Planning Commission Staff Report

September 13, 2017
Item 6.a

- SUBJECT:** PUD-117
- APPLICANT:** Jitender Makkar
- PROPERTY OWNER:** One Odevelopment LLC
- PURPOSE:** Workshop to review and receive comments on an application for Planned Unit Development Rezoning and Development Plan to construct six single-family homes, a public trail, and related improvements on an approximately 12-acre site
- LOCATION:** 2188 Foothill Road
- GENERAL PLAN:** Low Density Residential
- ZONING:** Agriculture (A), West Foothill Road Corridor Overlay District
- EXHIBITS:**
- A. [Planning Commission Workshop Topics](#)
 - B. [Proposed Plans dated "Received June 15, 2017," Geotechnical Report \(2001\) and Update \(2015\), Geological Report, Environmental Noise Assessment, Biological Resources Assessment, and Arborist Report](#)
 - C. [Staff Comment Letter dated March 4, 2016](#)
 - D. [Public Comments](#)
 - E. [Location and Notification Map](#)

Figure 3: Proposed Site Plan (Partial)

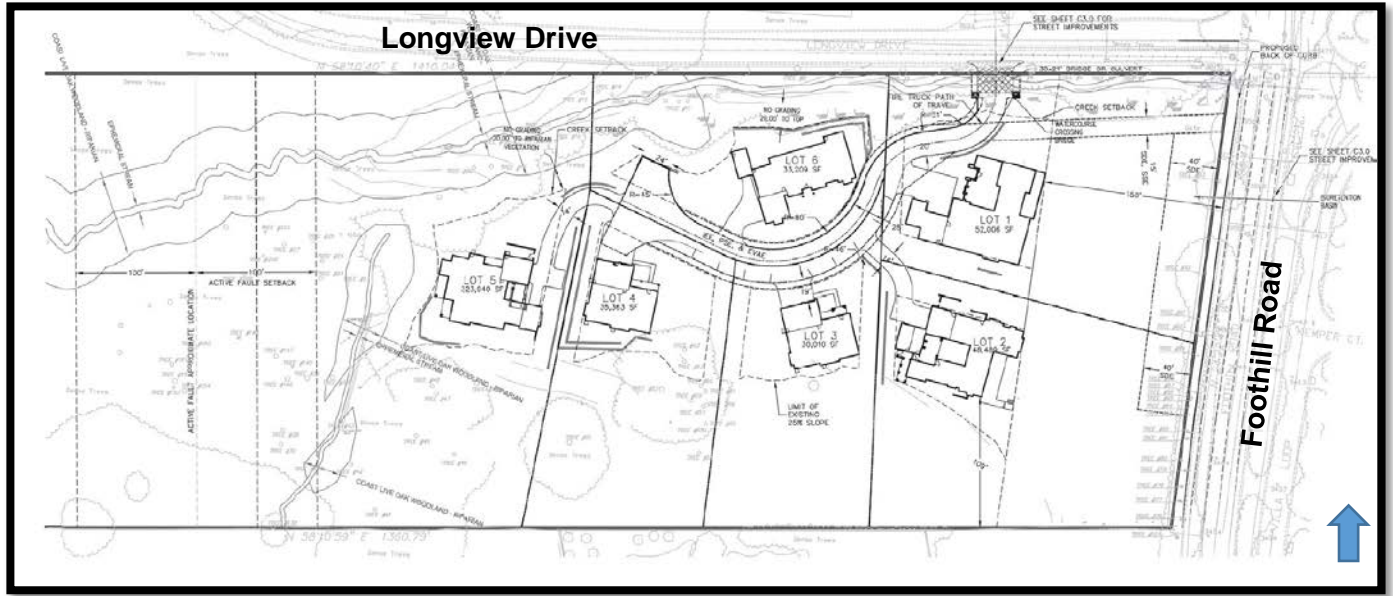
Please note that staff is working with the applicant to eliminate discrepancies shown on the current plans specifically, the Horizontal Control Plan shows a 40-foot wide street whereas the Site Plan shows the street would be 20 feet wide near the entrance and would turn into a 28-foot wide street. In addition, there are discrepancies between some of the setbacks shown in the plans and indicated in the Site Development Standards. Staff will ensure all plan sheets are consistent when the application is brought back before the Commission for its formal review.

The project site is highly visible from Foothill Road. To reduce the visual impacts of the homes and to meet the setback required sideyard setback, staff recommends that Lot 2 be eliminated so as to provide more open space immediately adjacent to the sensitive Foothill Road corridor.

A public trail is proposed, and the proposed trail is located between Longview Drive and Lot 6. It is not sensitive or ideal to have a trail located in close proximity to residential lots. Trails should be located with open space area on both sides. As such, for a better trail location, staff recommends that Lot 6 be eliminated to minimize impacts from the trail users to the residential property, and vice versa.

The proposed meandering street off Longview Drive ends at a hammerhead at its western end to provide the required turn-around area for fire trucks. A portion of the hammerhead is located in Lot 4's driveway area. Because no vehicles would be allowed to park in the hammerhead area, Lot 4's driveway will need to be redesigned to be located completely out of the hammerhead. This may require the home on Lot 4 to be relocated so that the driveway ties into the private street east of the hammerhead.

- It should not include any portions of the street;
- It should be located 10 feet from the edge of the proposed private street and the edge of the proposed hammerhead; and
- It should be located to meet the WFRCOD side yard setback requirements.

Figure 5: Proposed Front Elevations -- Lots 4-6

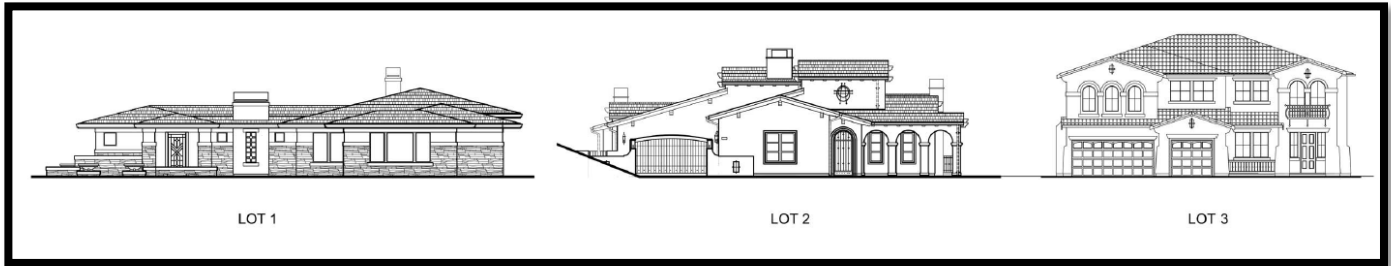
Homes on Lots 3-6 would be constructed on flat pads. Staff finds the home designs to be generally acceptable, but recommends that the side and rear elevations of the homes on Lots 3 and 4 be improved to provide a four-sided house design (i.e., utilize some of the architectural details/elements/materials from the front elevations on the side and rear elevations). Staff finds that the proposed building material and color palettes are appropriate for the project area.

Figure 7: Conceptual Trail Alignment

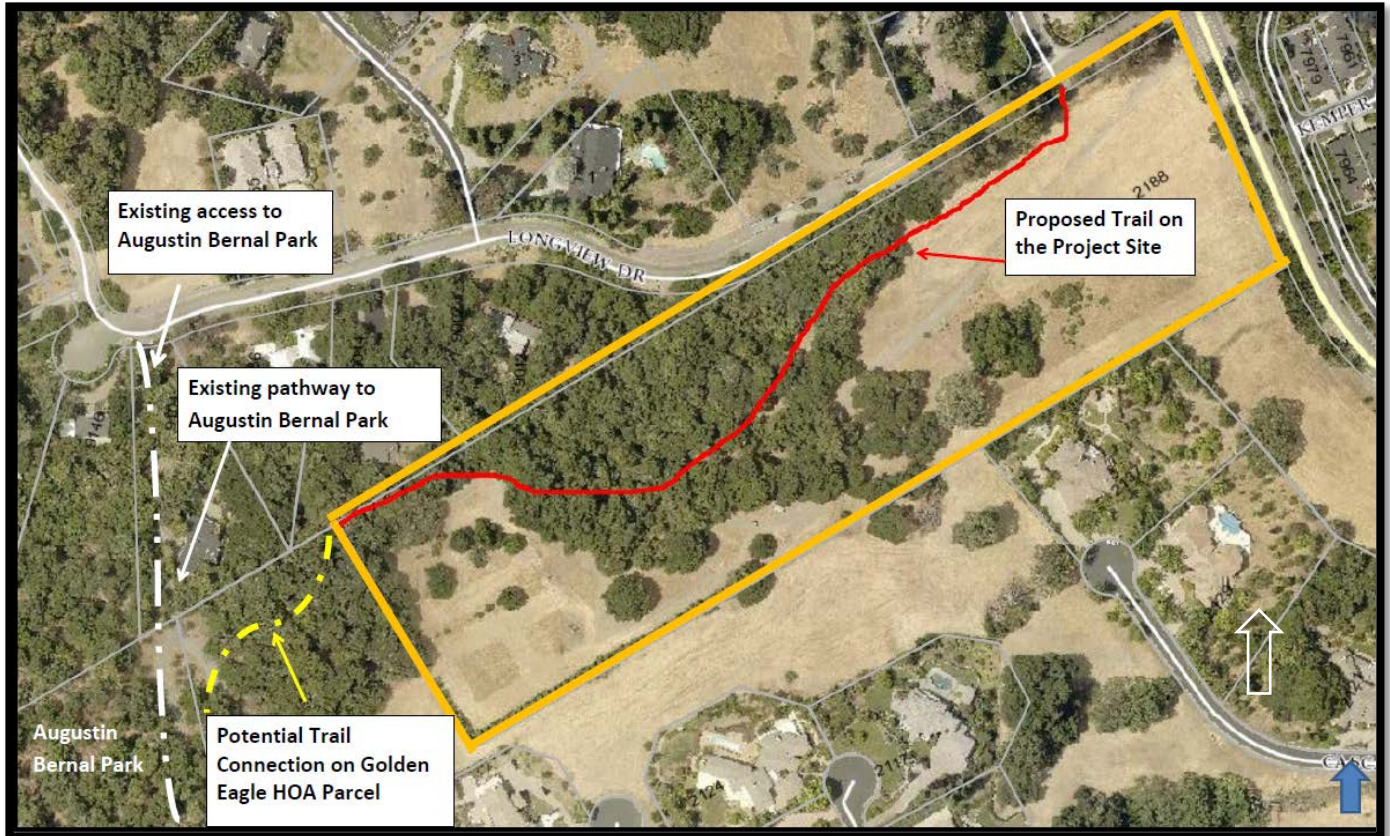
A public trail is proposed as part of the project. The gold line in Figure 7 demarcates the approximate boundary of the 12-acre subject property; the red line shows the proposed conceptual trail alignment up to the property line abutting Golden Eagle HOA land; the yellow line shows possible connection of the proposed trail to the existing path on Golden Eagle open space which leads to the pathway to Augustin-Bernal Park. Please refer to the earlier section regarding discussions with Golden Eagle Farm HOA of the proposed trail connection. In summary, staff believes that development of a public trail on the site, ultimately connecting to Augustin-Bernal Park, would be a desirable amenity for Pleasanton residents.
